MEMORANDUM

To: Bidders for:
14 Riverside Drive Renovations
14 Riverside Drive, Asheville, North Carolina 28801

Re: **ADDENDUM NO. 3**
14 Riverside Drive
City of Asheville

The attached is **Addendum No. 3**, which includes additions, deletions, modifications, and/or clarifications to the above referenced Project Documents released for bids on June 13, 2016, and dated October 27th 2015. Please incorporate this into your Bid Documents upon receipt and sign the "Form of Proposal" acknowledging receipt of Addendum No. 3. The date for receipt of bids remains unchanged. It is 2:00 PM, Wednesday, July 6th, 2016.

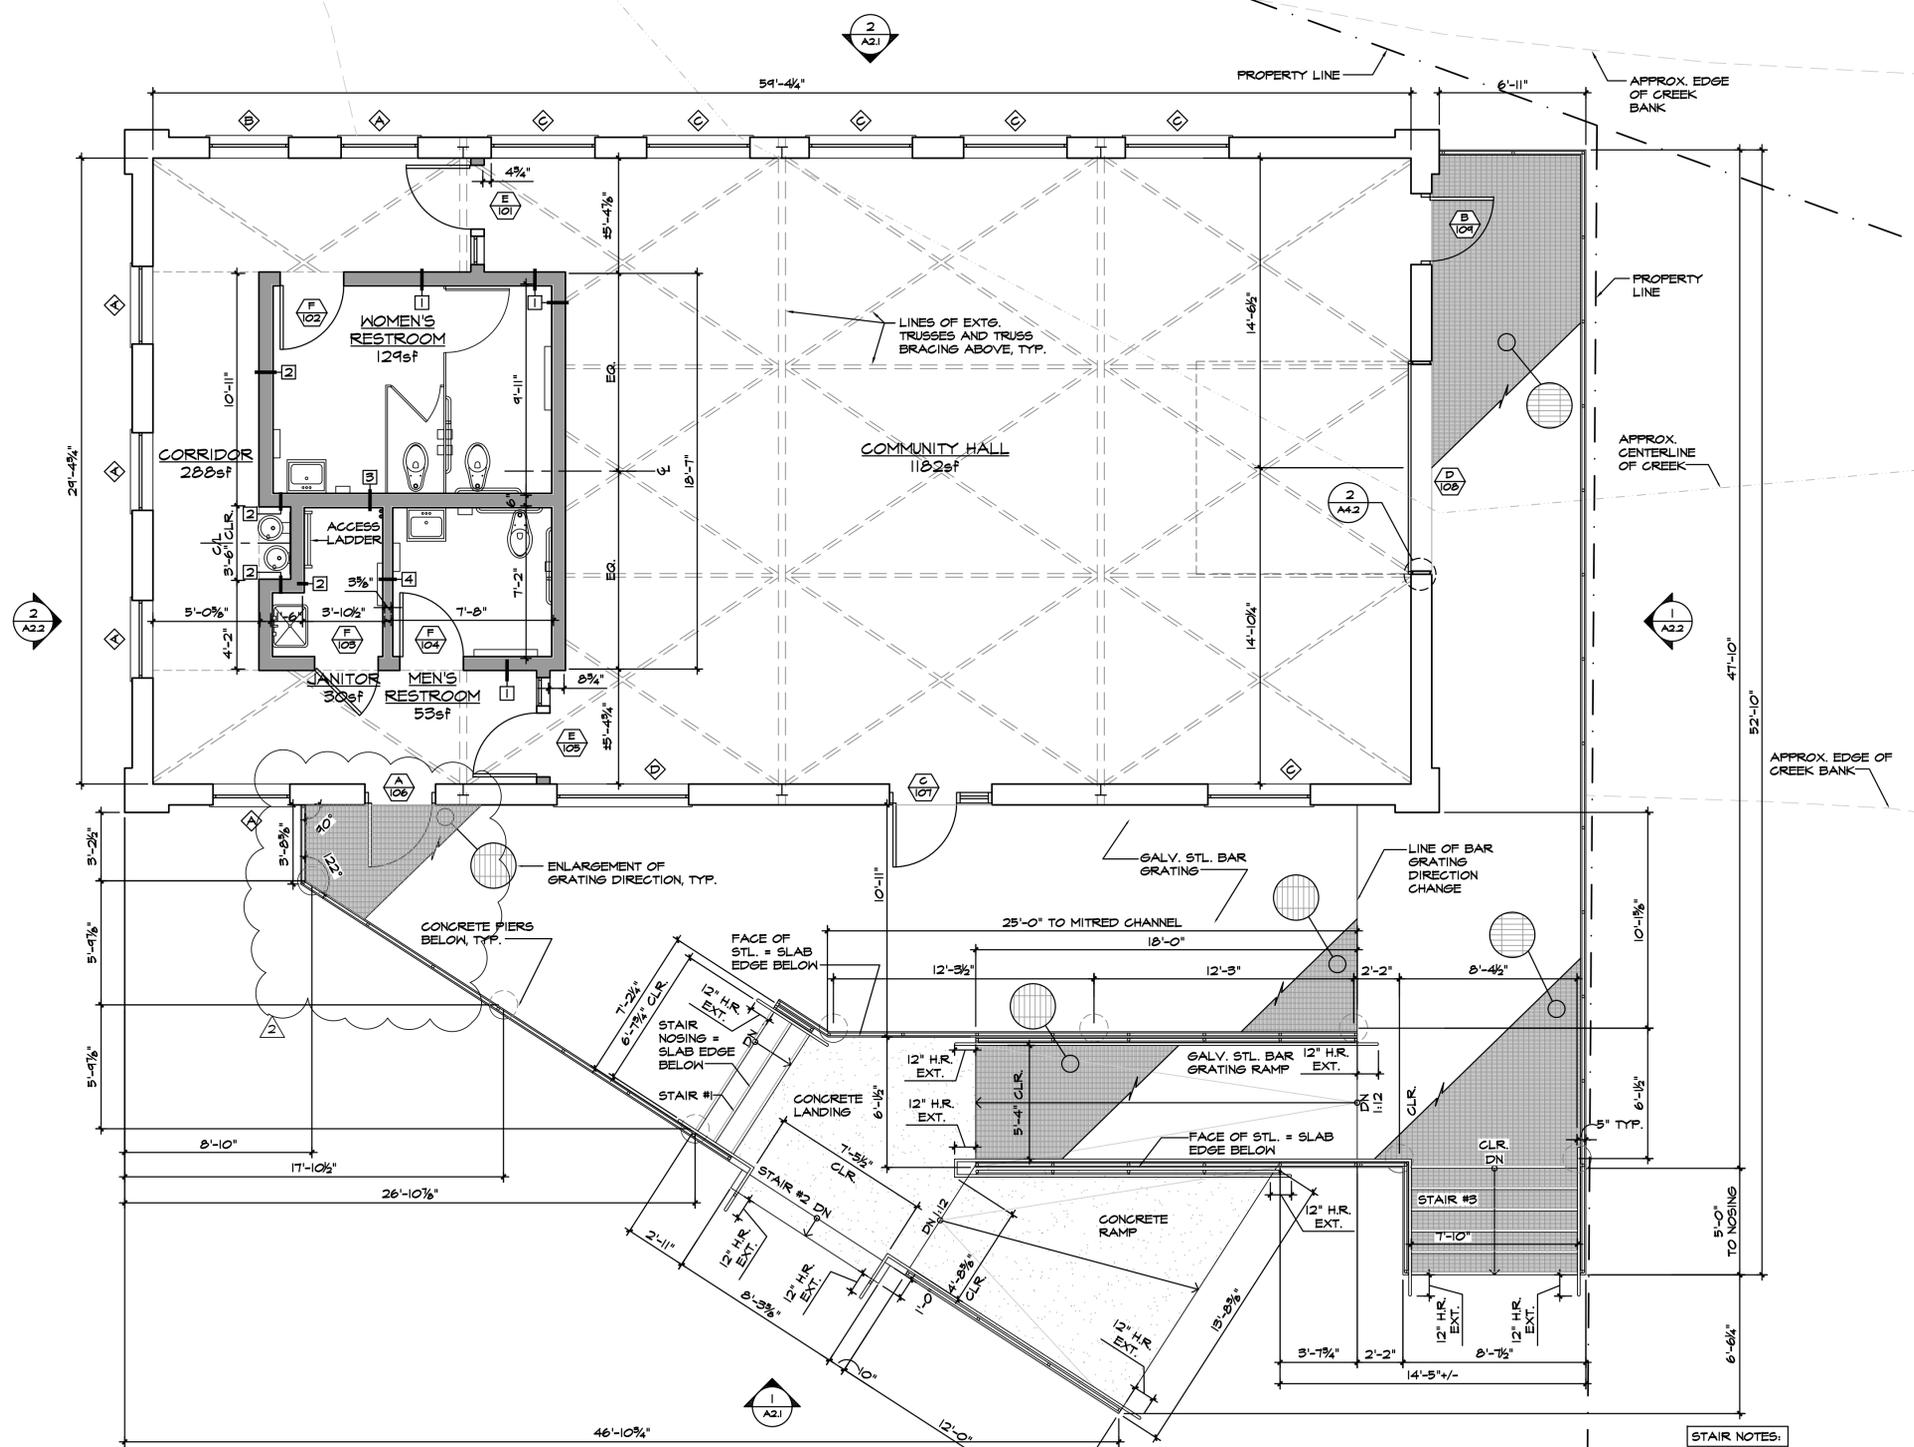
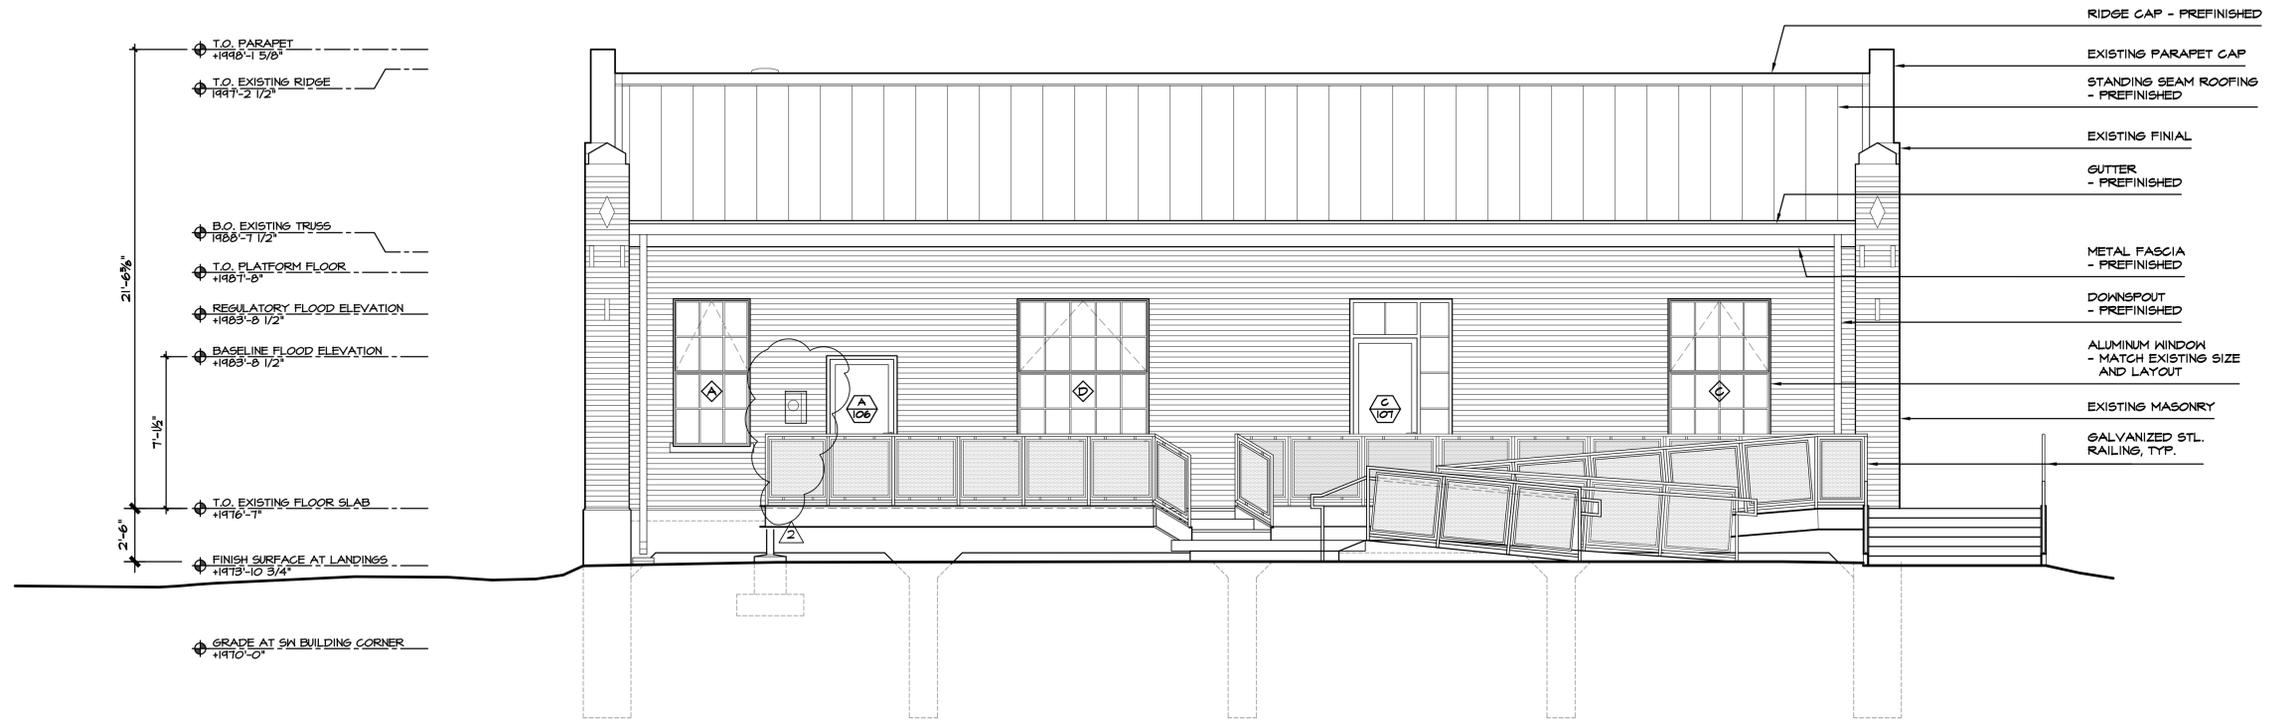
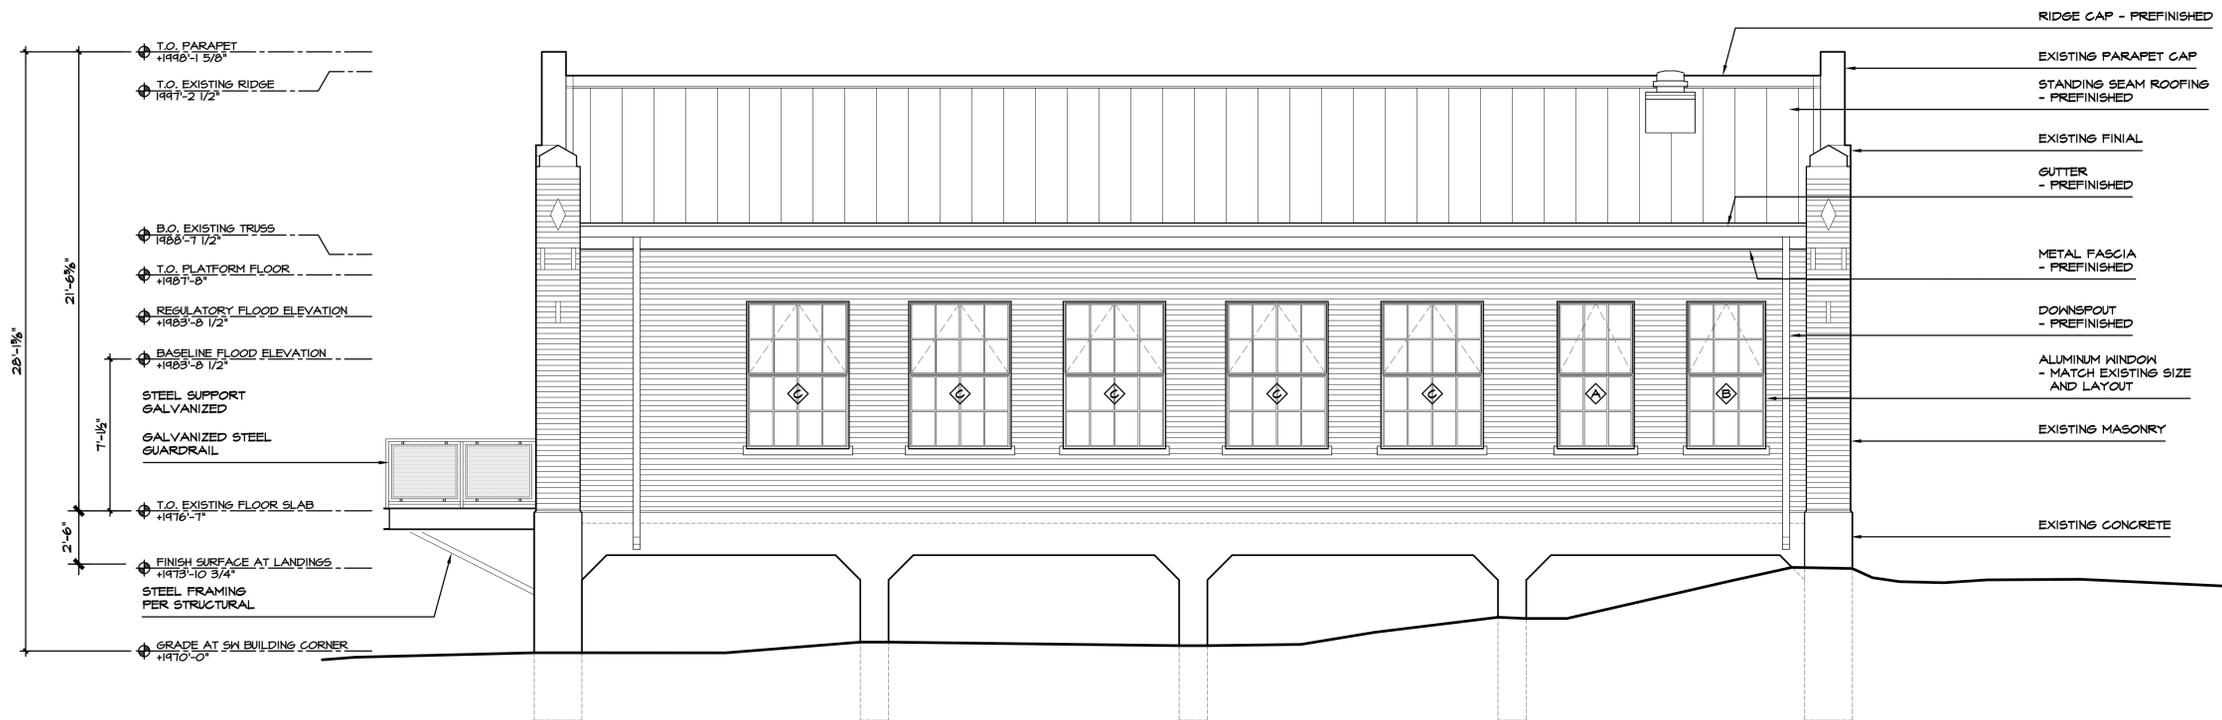
Please find attached Revised Drawings A1.1 and A2.1 revised 6/29/16. These drawings outline modifications to the exterior deck as a result of the change of location of the Building Power Service Meter.

DECK FRAMING PLAN
1/4"=1'-0"
1. SEE ARCHL DWGS FOR ALL PLAN DIMENSIONS.

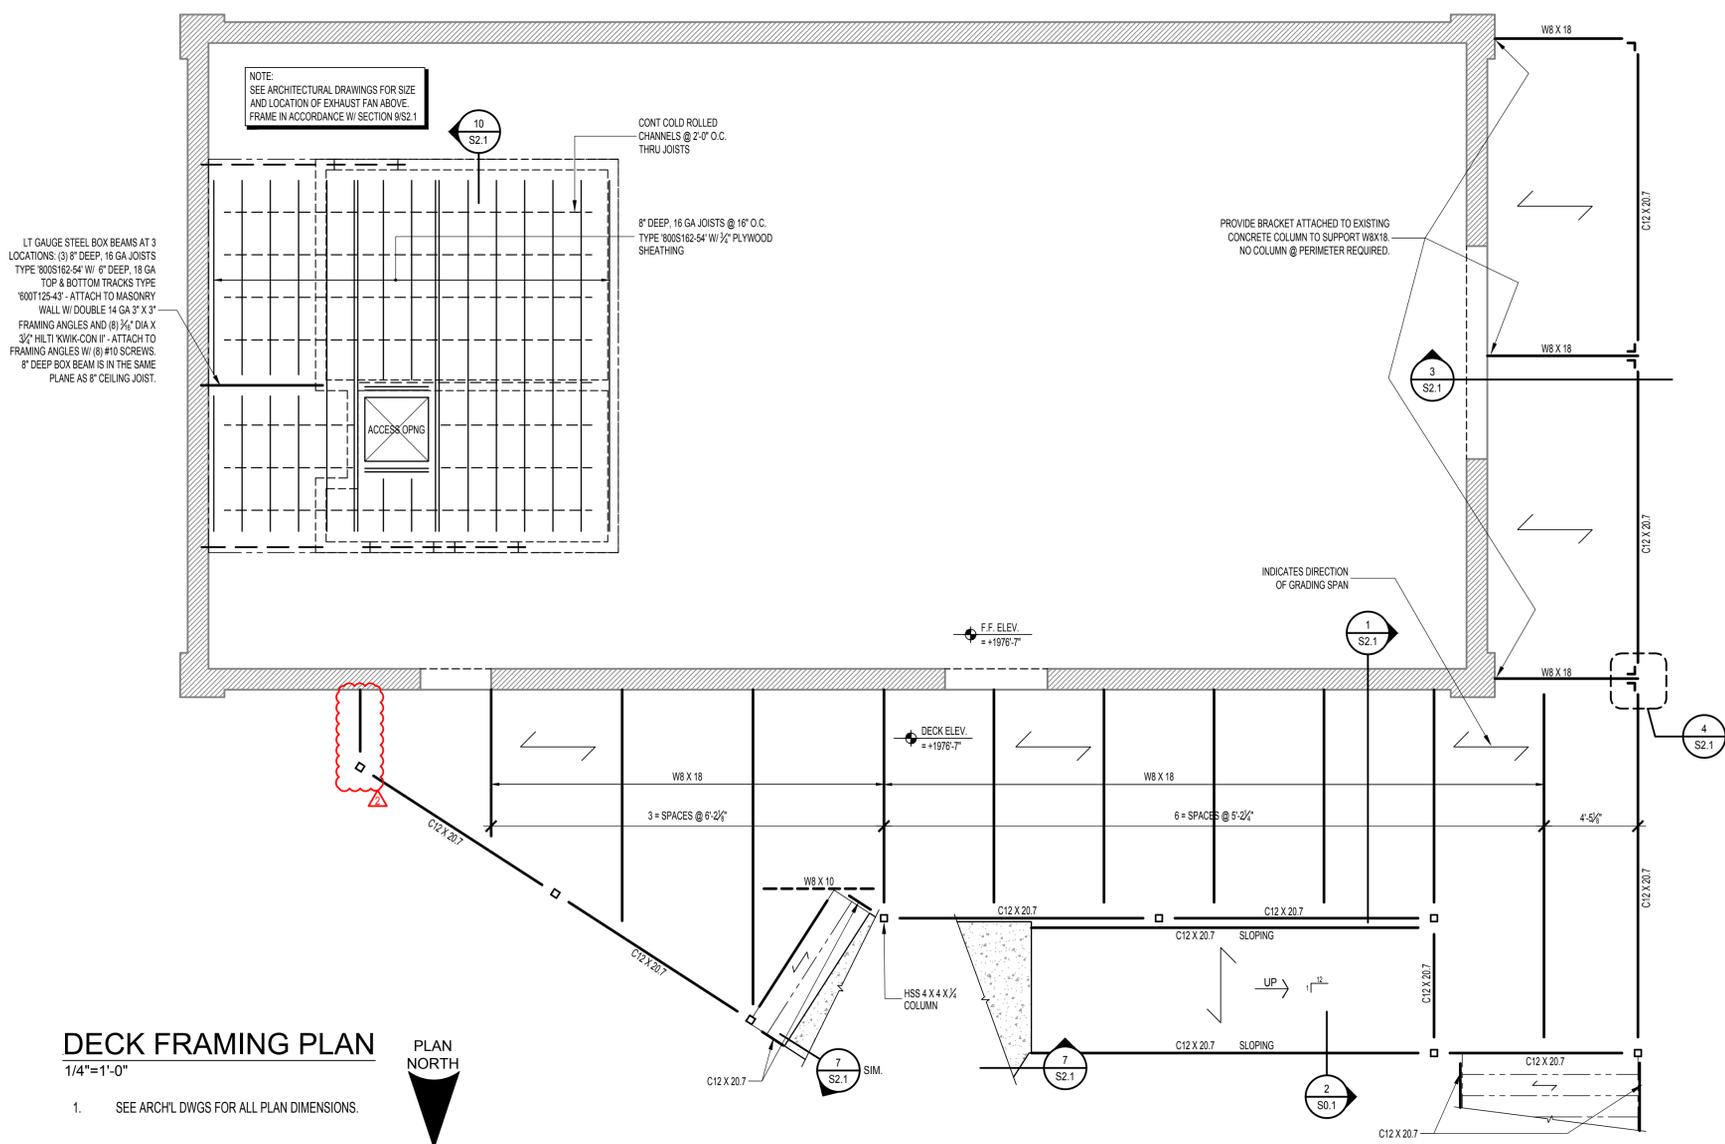
Please find attached Sheet S1.2, Revision #2 with revision to the exterior deck to accommodate the relocation of the Building Power Service Meter.

CLARIFICATION E-3

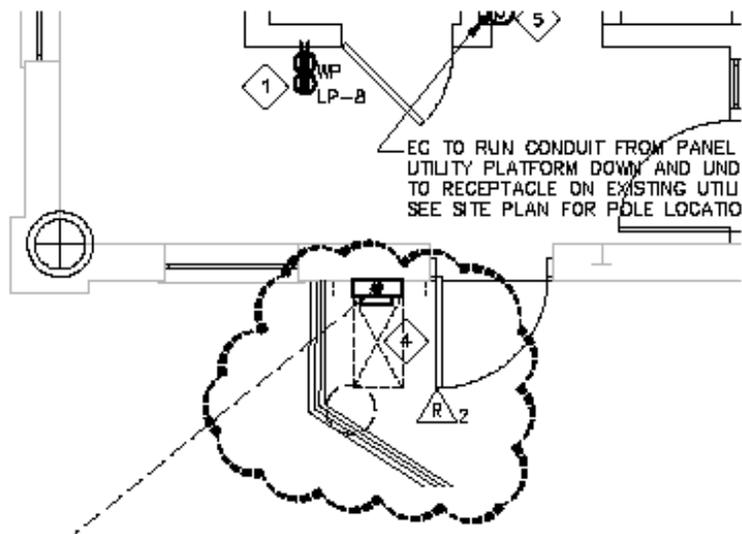
REFERENCE SHEET E1.0, DETAIL 2: Meter base/service disconnect mounting location to move plan West to wall space behind door, between door and window. SEE BELOW--
